Minutes of 81st PCC Meeting

MINUTES OF 81ST PROTECTION SUB-COMMITTEE MEETING HELD AT ERPC, KOLKATA ON 18.07.2019 (THURSDAY) AT 11:00 HOURS

Fig 1: Line Current measured at Ranchi end for 400 kV Ranchi - RTPS – II from PMU indicating multiple reclosure

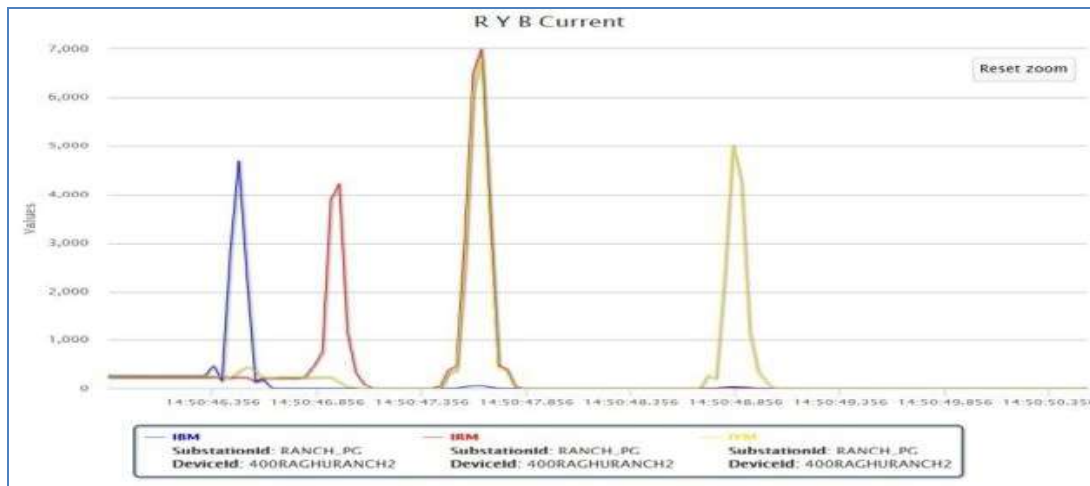
400 kV Ranchi - RTPS - II tripped at 14:50 hrs on 31-05-19 due to fault in the circuit. As per PMU data, A/R of 400 kV Ranchi – RTPS – II started from both ends at 14:50:46.360 hrs (approx) on 31-05-19 on B-N fault. During this, B phase has opened from both ends of the circuit. At 14:50:46.800 hrs (approx), another fault occurred in the R phase and with this the other two poles also opened from both ends thus tripping the circuit. However, it is observed that A/R attempt was again taken at Ranchi end in the faulty R & Y phases at 14:50:47.400 hrs (approx) and Y phase at 14:50:48.800 hrs (approx) even after the three poles opening at 14:50:46.800 hrs (approx). Such repeated auto-reclose operation is not desirable due to vicinity of the generating station for reliability and security.

In 80th PCC meeting, Powergrid informed that repeated autoreclose operations at Ranchi end was due to some issues in autoreclosure scheme. The scheme was referred to OEM for analysis and recommendations.

Fig: 400 kV Bihar Sharif Bus Voltage during the event indicating different A/R timing on 400 kV Koderma-Bokaro 1 circuit

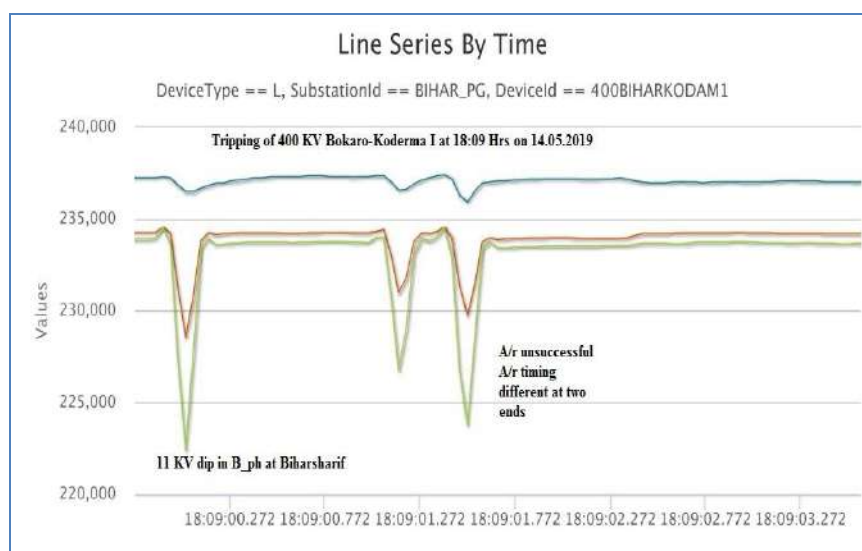
400 kV Koderma-Bokaro-I circuit tripped at 18:09 Hrs due to Y phase to earth fault. In the PMU plot for generator voltage, different dead time has been observed at two ends leading to two faults being fed to the system one by one with A/R operation. It may kindly be noted that, both ends of the line is connected to major generating station of Eastern region and the feeding of fault on two occasions due to different A/R timing is not desirable.

DVC informed that the issue of different autoreclose time was due to uploading of wrong settings file to the relay. They added that the same would be rectified very soon.

Figure 8: Dikchu end Pre and during fault Voltage and Current Phasor

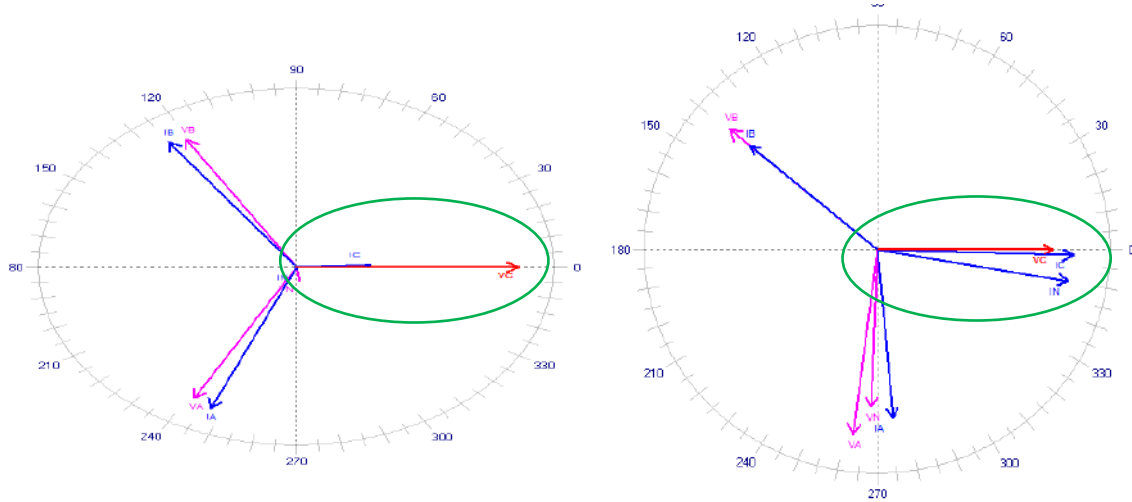
From the DR of Dikchu as well as Rangpo end it is seen that the Phase angle between B phase voltage and current is nearly zero both during pre-fault and fault condition (for the

first 1.1 sec). Only magnitude of the current increases from 1.2 kA during pre-fault condition to 3.5 kA during fault condition. **Also calculating active power supplied to the fault from Both Rangpo and Dikchu end it is seen that almost 1300 MW was consumed by the fault. The same is evident from the PMU measurements also.** Physical nature of such high resistive fault needs to be investigated with due diligence.

2. Analysis of Dikchu ICT DR:

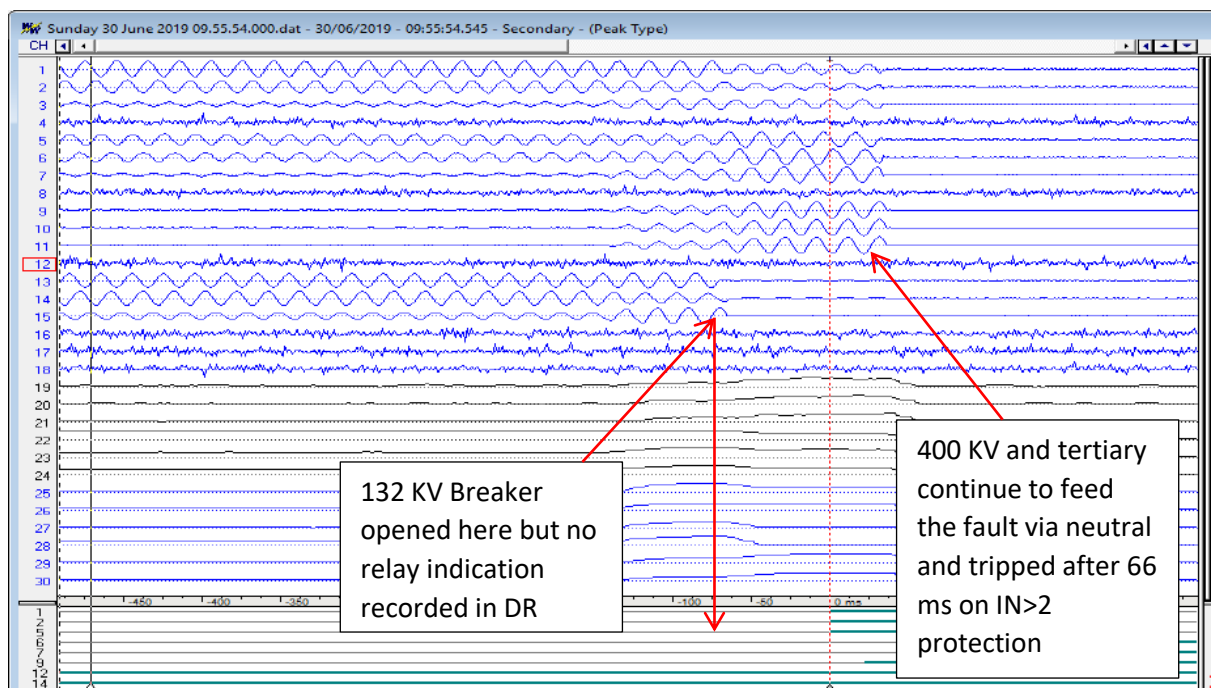
From the disturbance recorder, it was also observed that 132 kV side of ICT at Dikchu tripped earlier than 400 kV side. PCC advised Dikchu to look into it.

132 kV current opened 1st but which protection operated is not clear from the DR then after 66 ms 400kV barker tripped on IN>2 protection as fault was continued to fed via neutral.

3. DR analysis of 132 kV Rangpo-Chuzachen at Chuzachen:

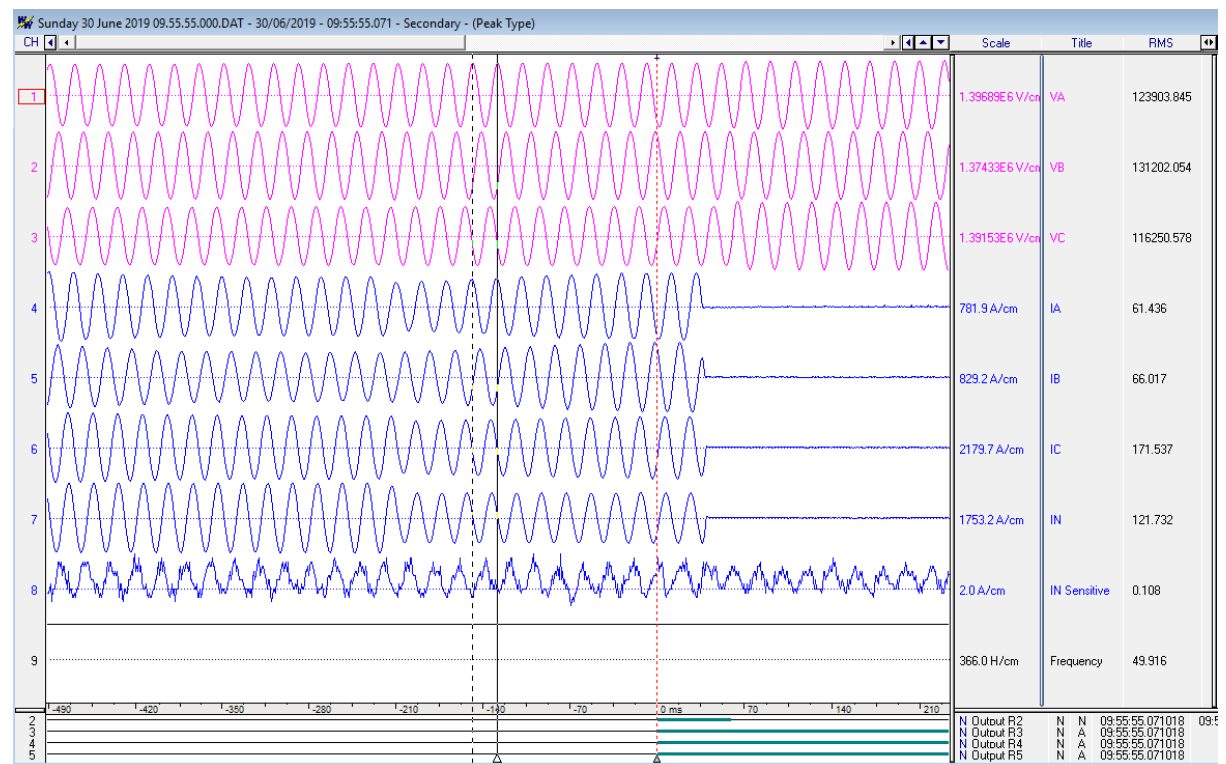
From Chuzachen end distance protection zone-3 operated as reported by them. But in the DR VTS blocking signal was high, which blocks zone protection. Chuzachen may explain the why VTS blocking was high and then how DP operated. Even if DP operated, then how zone-3 of the line encroached two voltage levels is not clear. Zone-3 setting may be reviewed.

Figure 11: PSSE study for calculating Phase angle difference between Rangpo and Teesta III

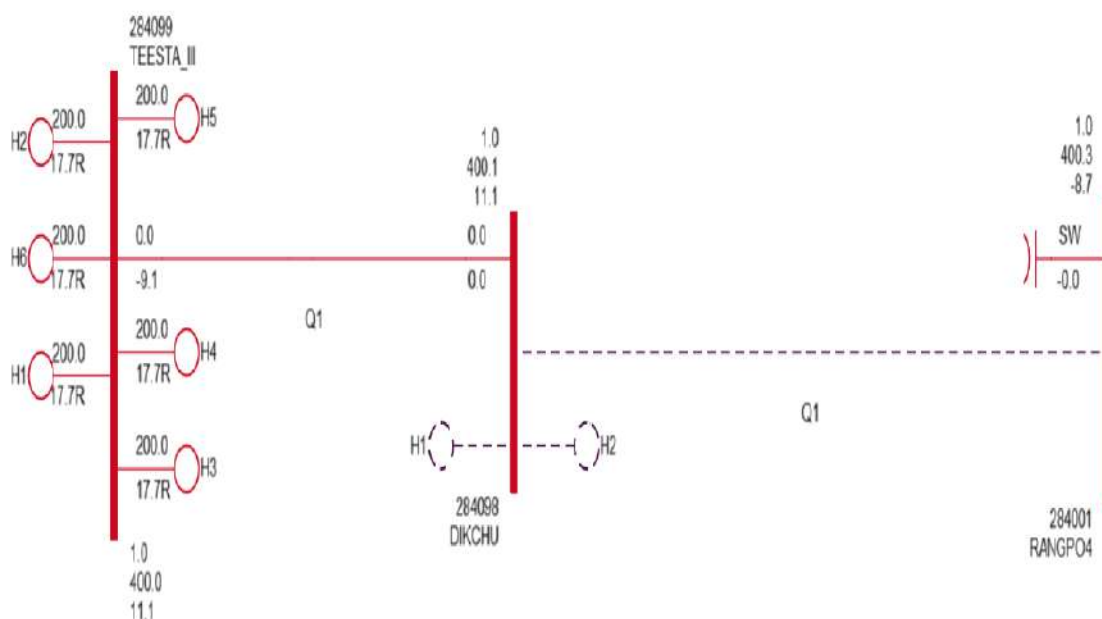
During restoration the phase angle difference between 400 kV Rangpo and Dikchu (or Teesta III) was more than 20 degree. Also in the study done by ERLDC and NLDC in PSSE similar angle difference is observed.

PCC advised Teesta-III & Dikchu to study the effect on their machine for synchronization at higher angular differences. Based on the study results, suitable settings for breaker closing conditions during synchronization can be evaluated.
